ALLEGHENY COUNTY SANITARY AUTHORITY

CONTRACT NO. 1759 G, E, H, P

ENVIRONMENTAL COMPLIANCE FACILITY

ADDENDUM NO. 4

Contract: 1759
CAD File Name: S-11.DGN
Date: 01 / 14 / 2022
Sheet: 47 of 287

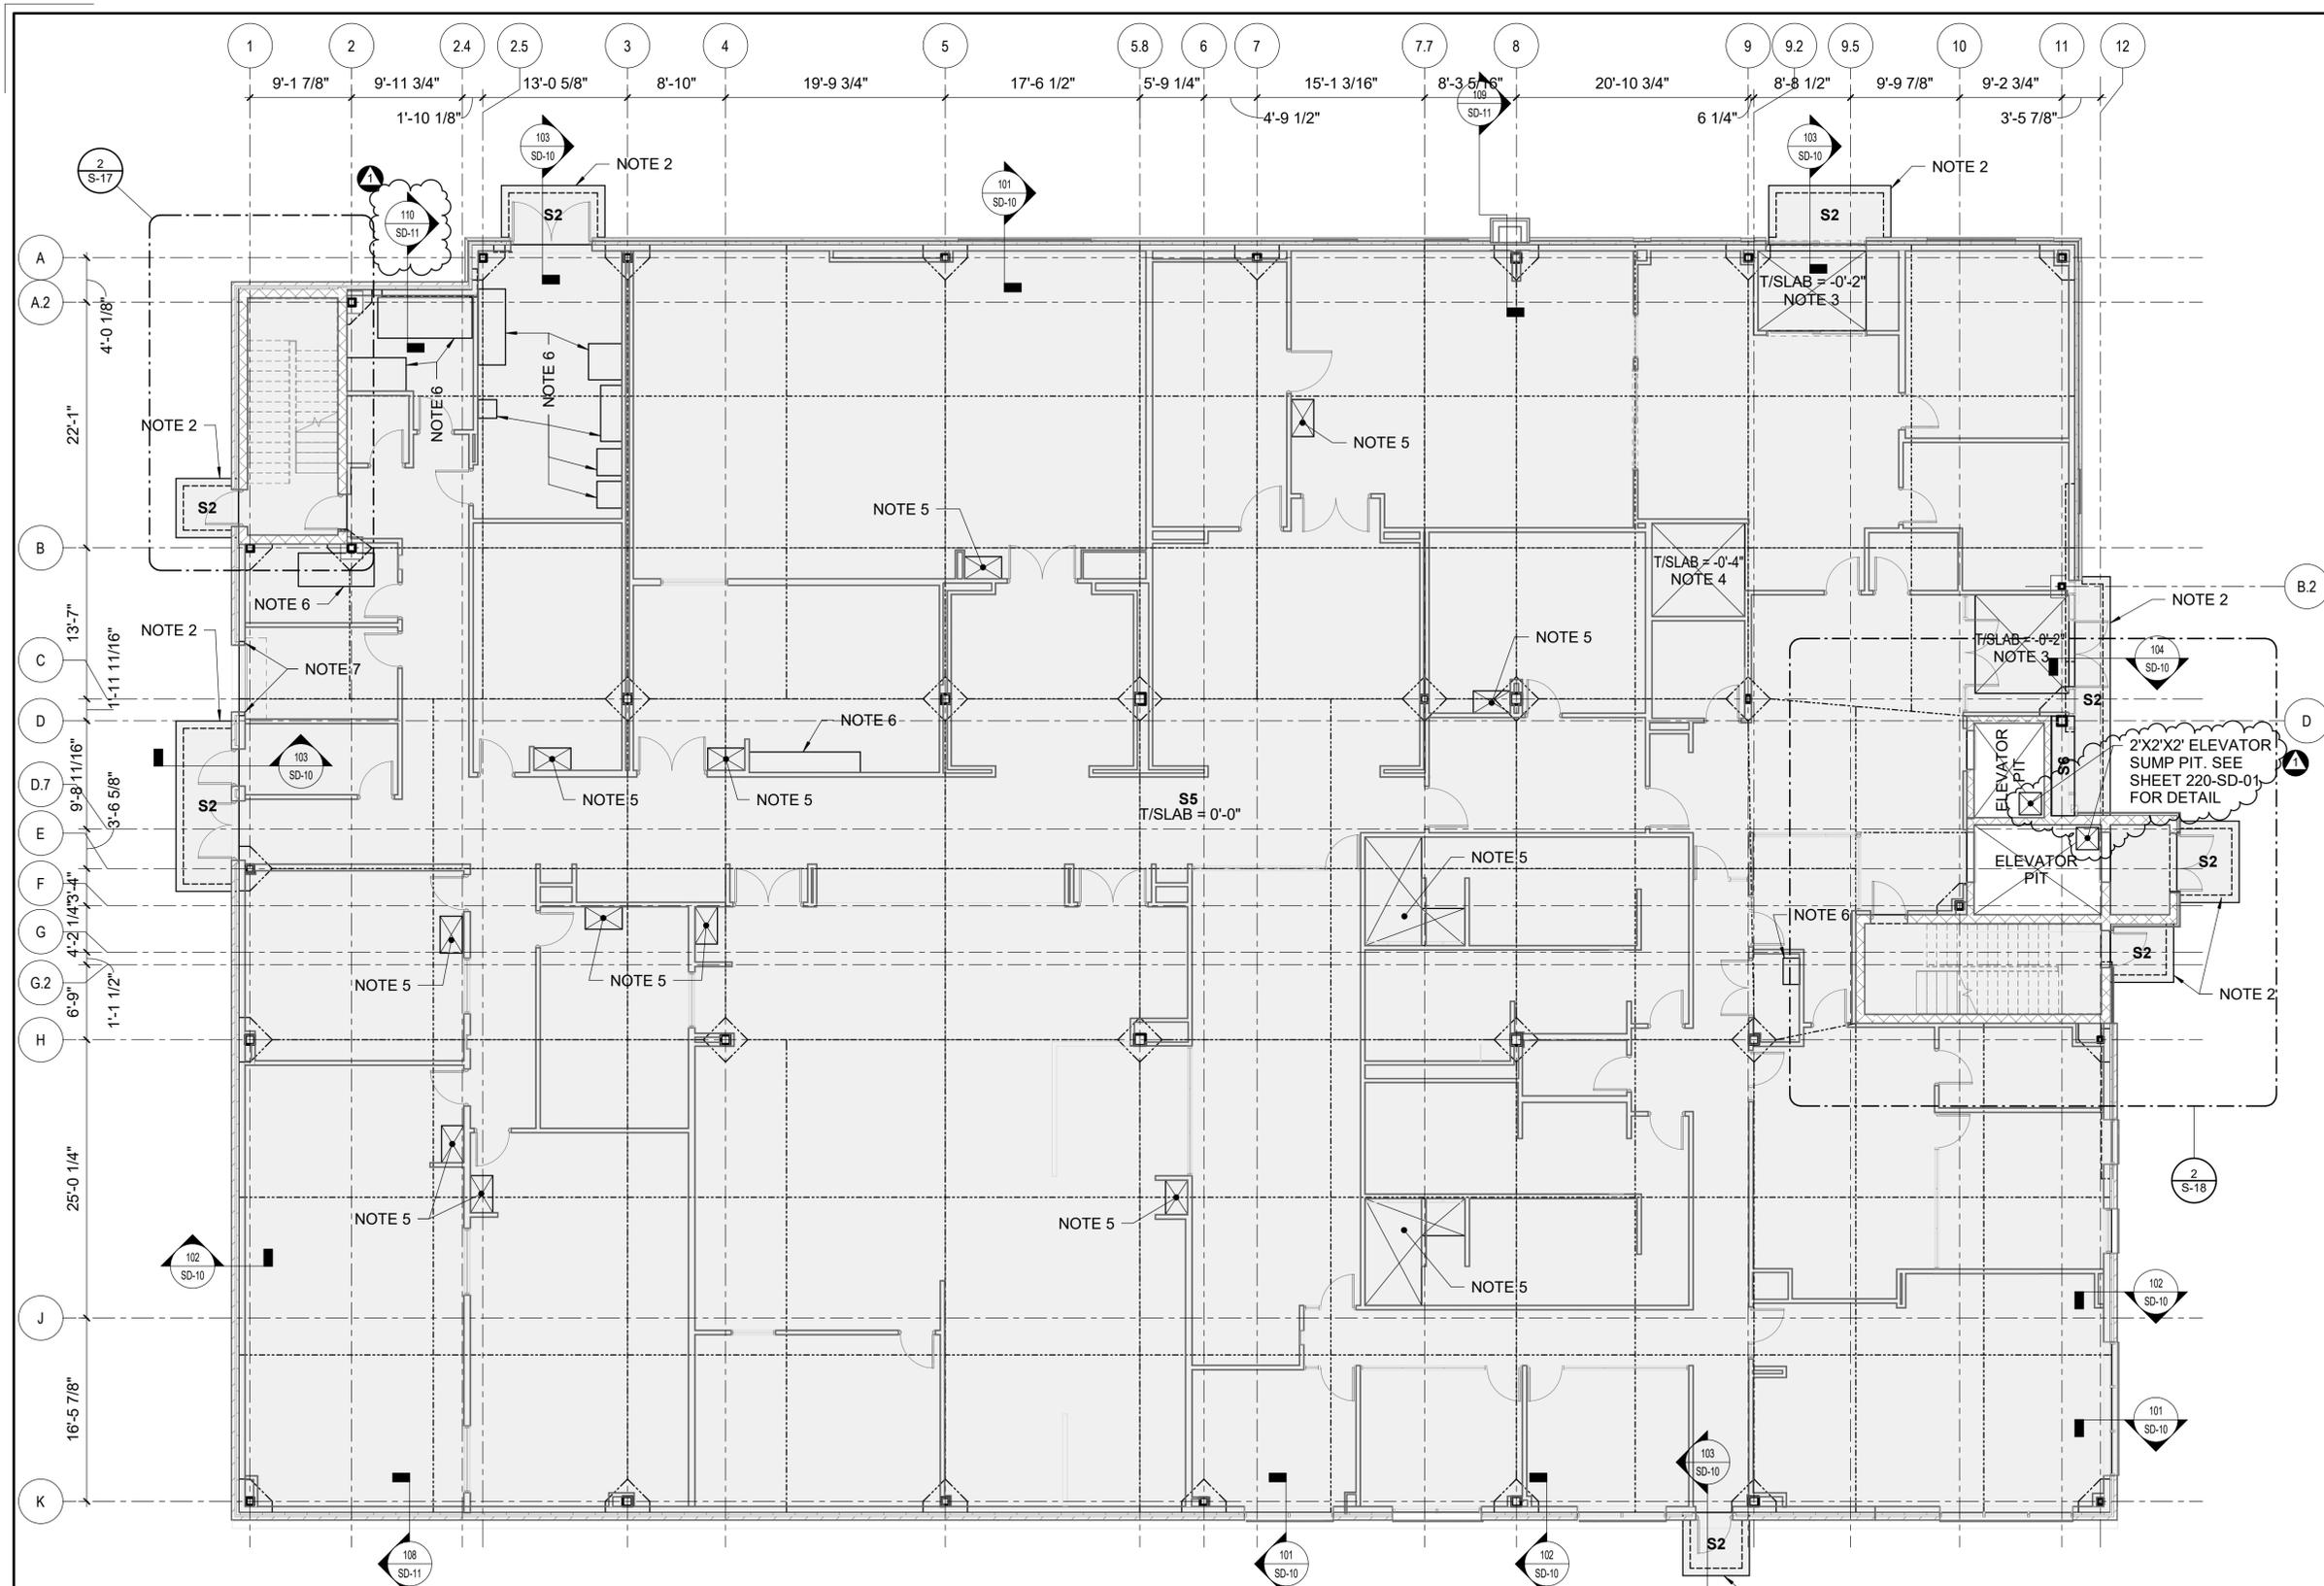
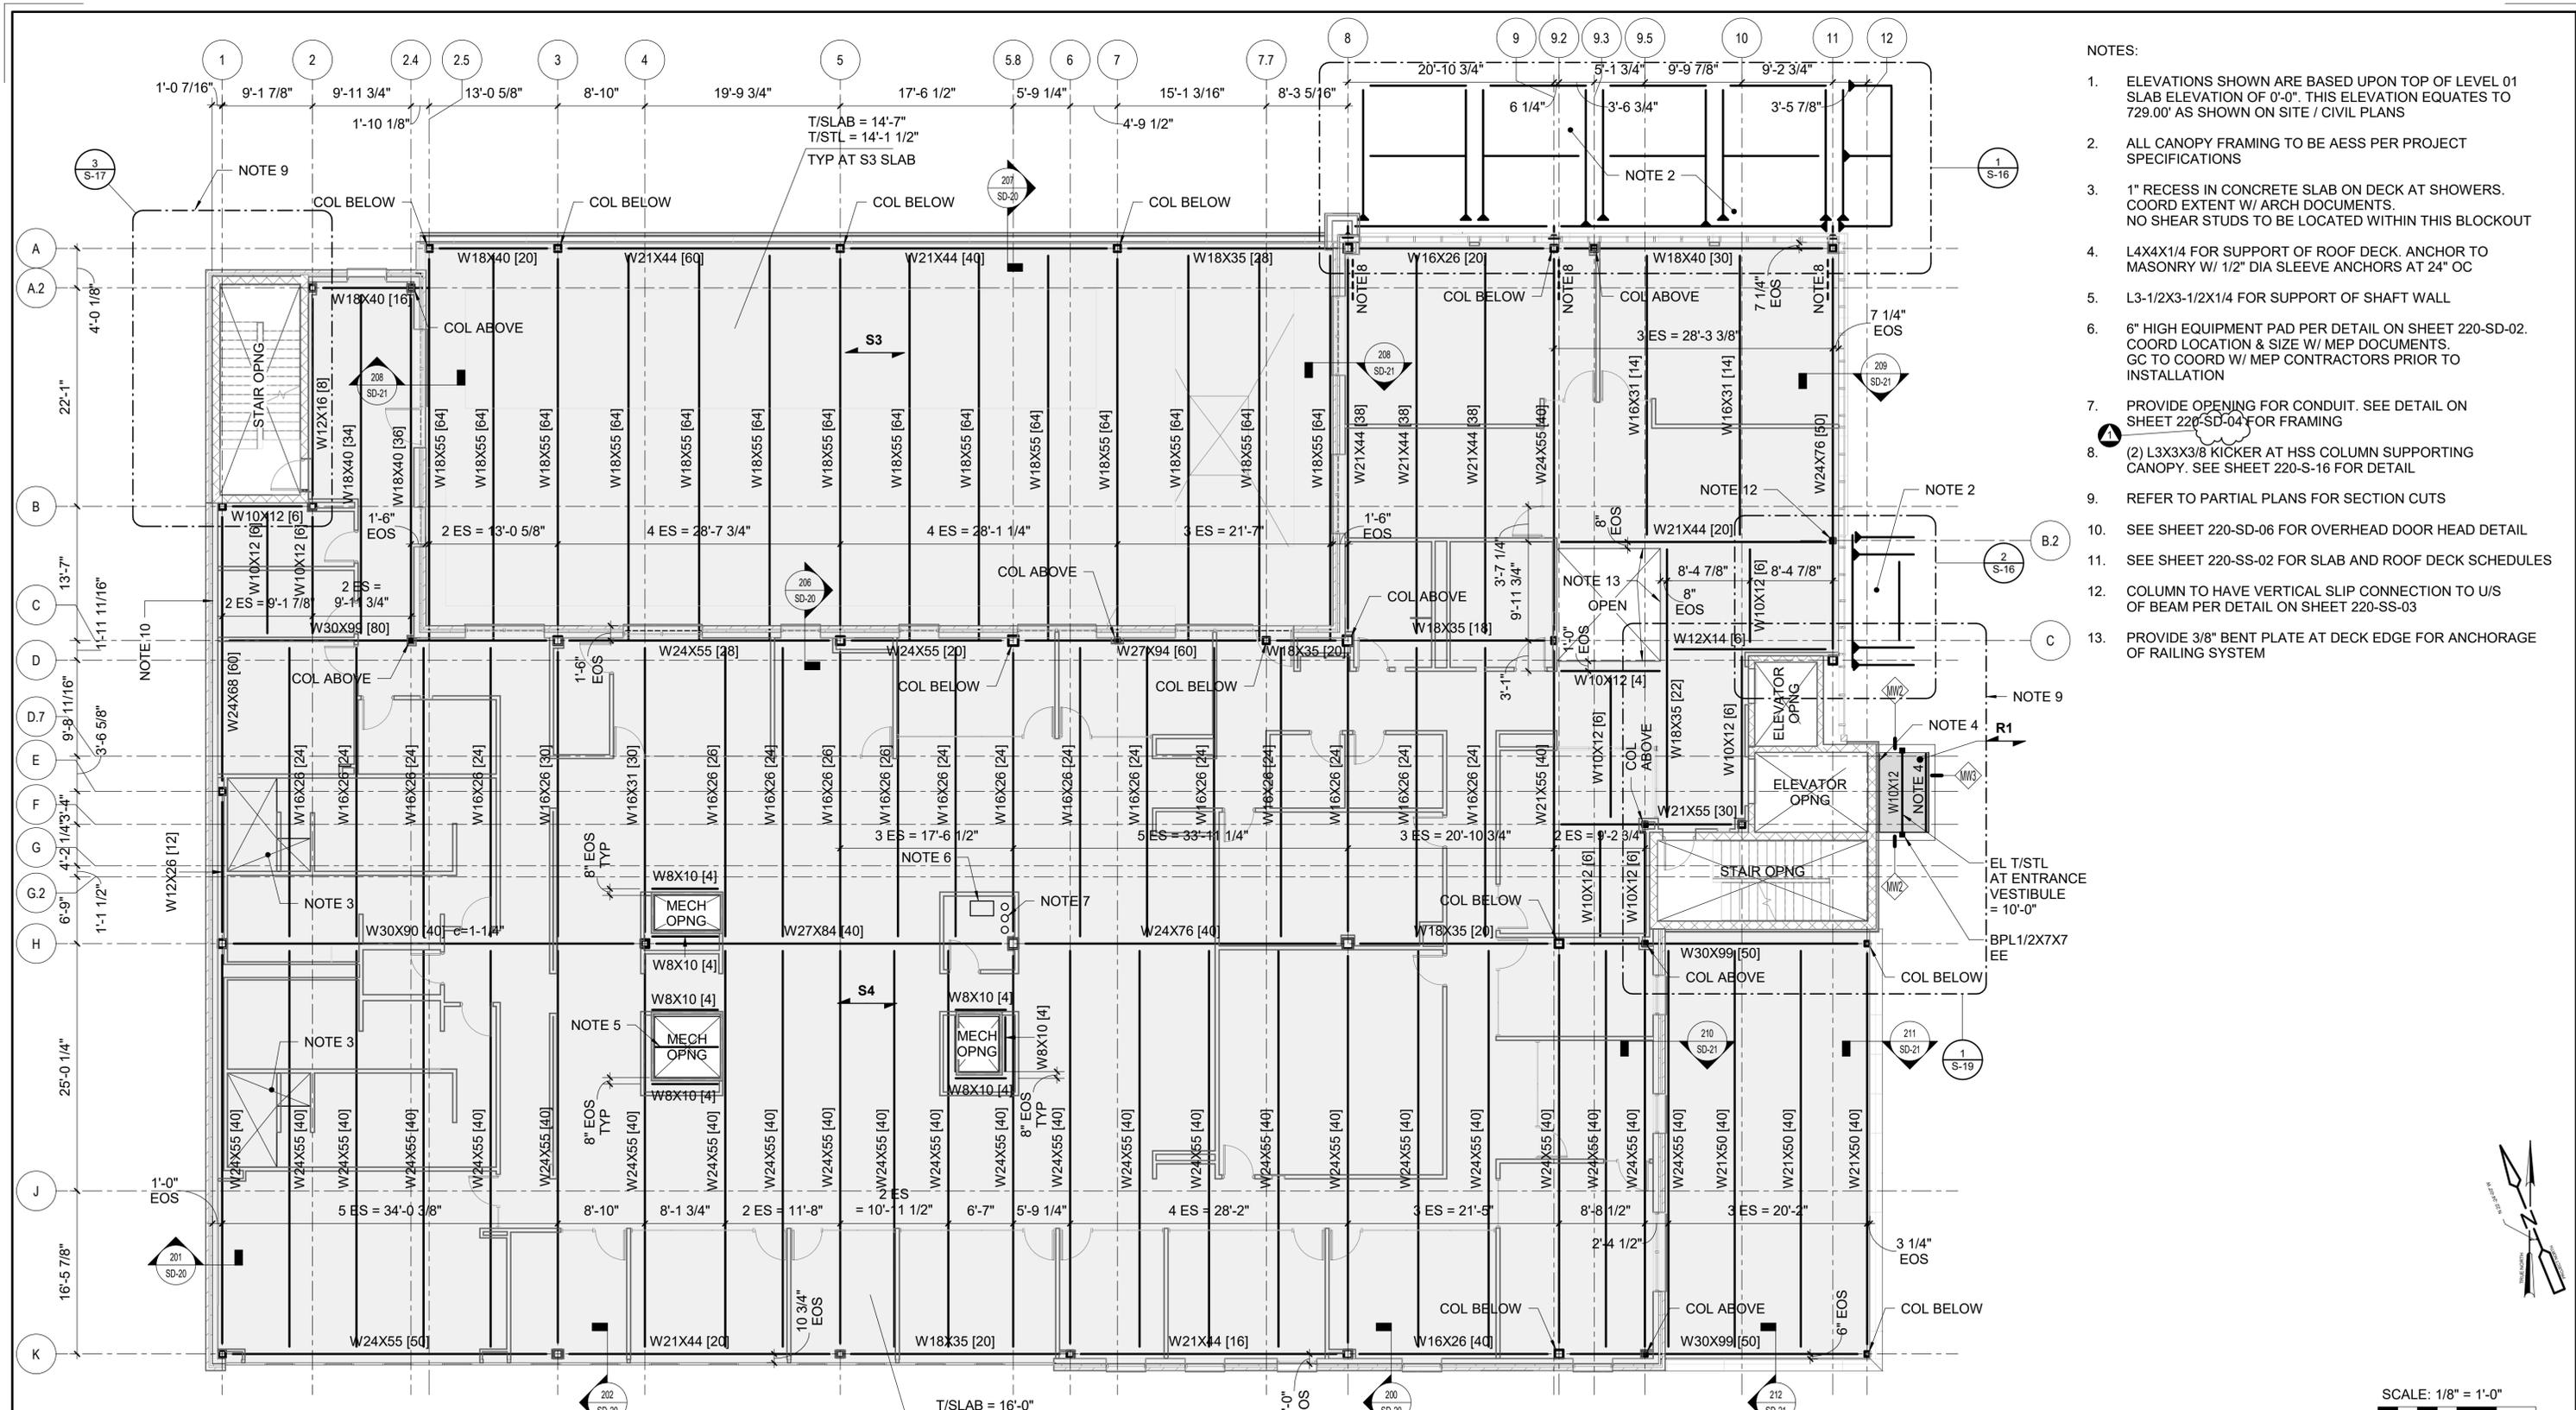
5. Drawing 220-S-11 – Level 01 / Slab On Grade Plan
 - a. REPLACE with the attached drawing 220-S-11.
 - b. Added a foundation wall near column A-2.4 and updated section mark.
 - c. Added elevator sump pits.

Q26: Please confirm that the section flag along the north exterior wall on drawing 220-S-11 between column line 5 and 5.8 should read 102/SD-10 and not 101/SD-10.

A26: Section 101/SD-1.0 is correct. There is not brick veneer on the north elevation at this location.

220-S-18
ENLARGED STAIR/ELEVATOR PLANS

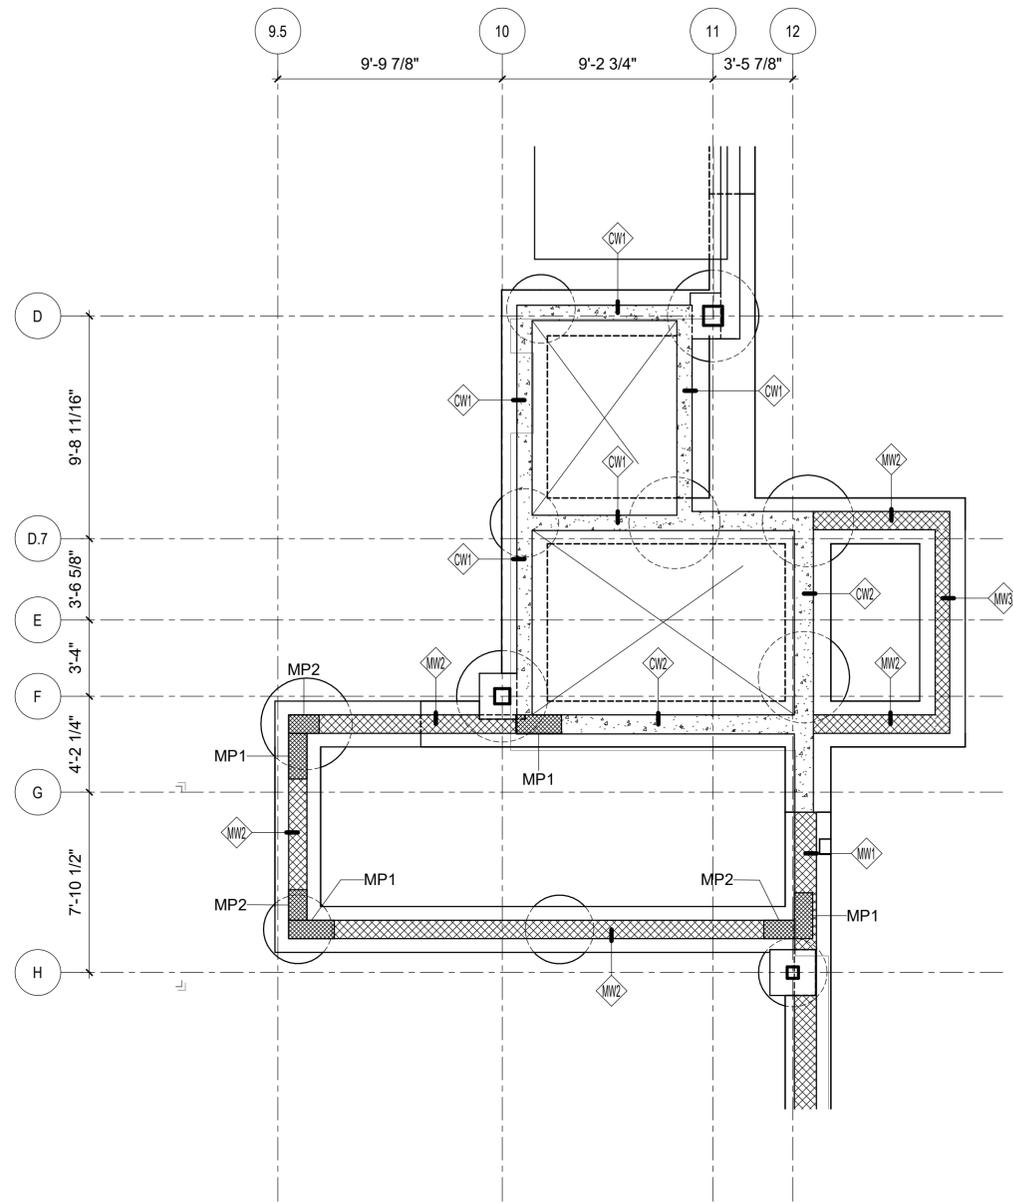
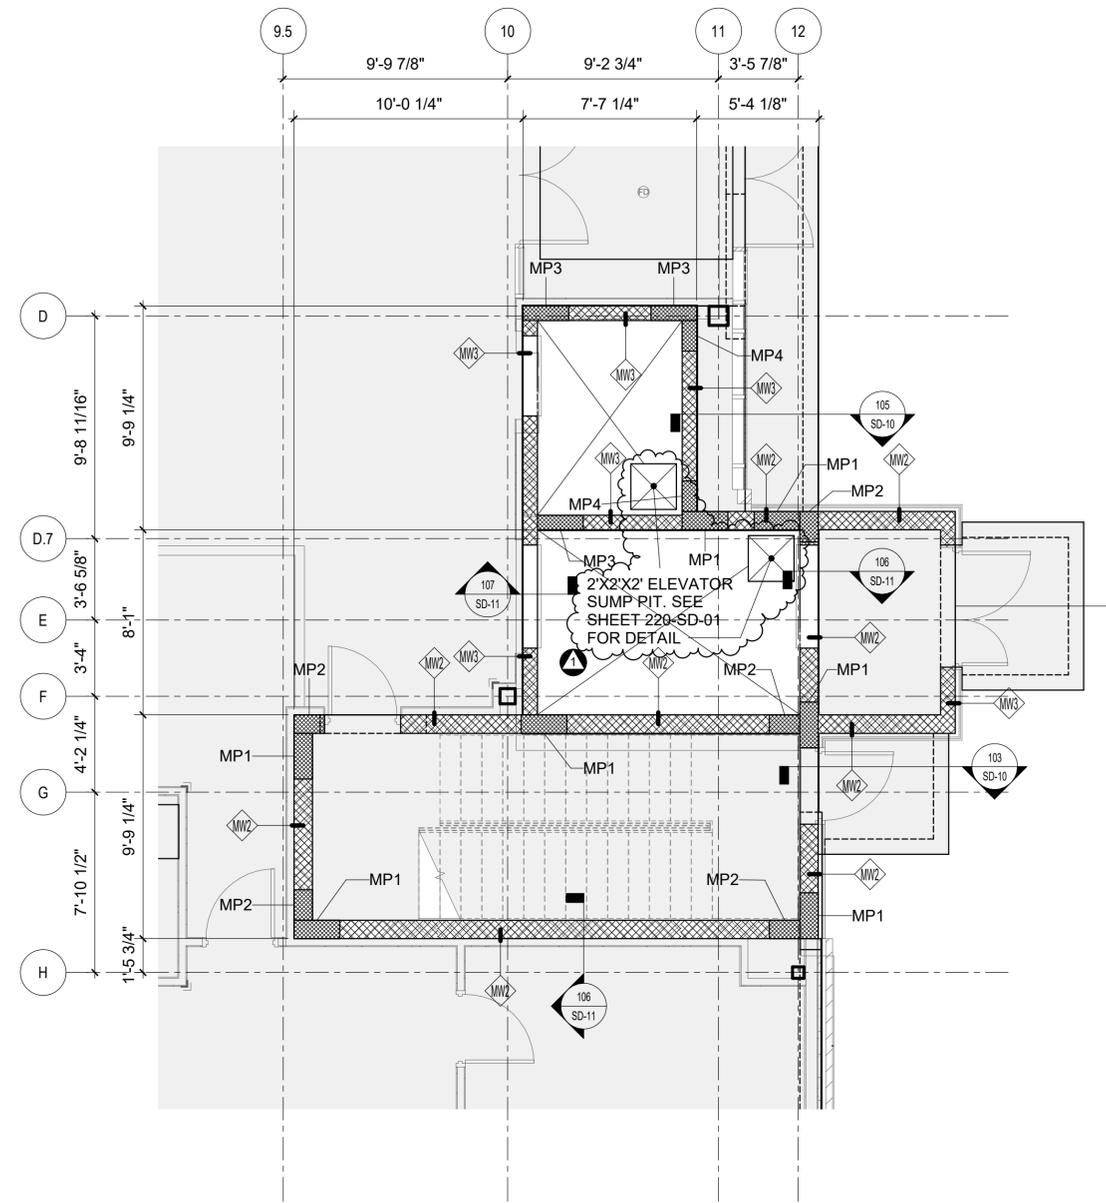
7. Drawing 220-S-18 – Enlarged Stair/Elevator Plans
 - a. REPLACE with the attached drawing 220-S-18.
 - b. Added elevator sump pits.

SECTION 110
SCALE: 3/4" = 1'-0"
SD-11

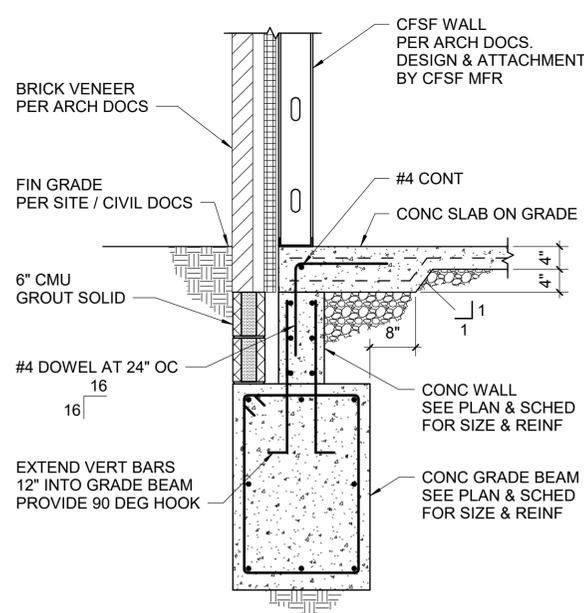
9. Drawing 220-SD-11 – Sections and Details
 - a. REPLACE with the attached drawing 220-SD-11.
 - b. Added section 110/SD-11.

SECTION 210
SCALE: 3/4" = 1'-0"
SD-21

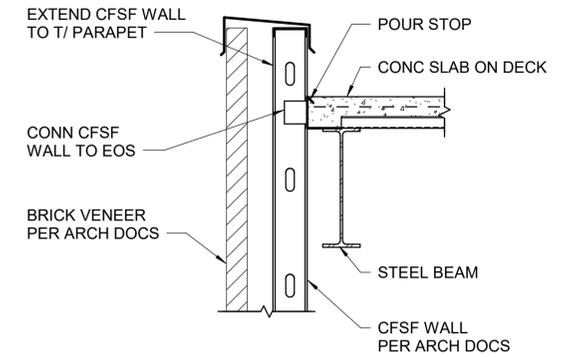
10. Drawing 220-SD-21 – Sections and Details
 - a. REPLACE with the attached drawing 220-SD-21.
 - b. Updated section 210/SD-11.
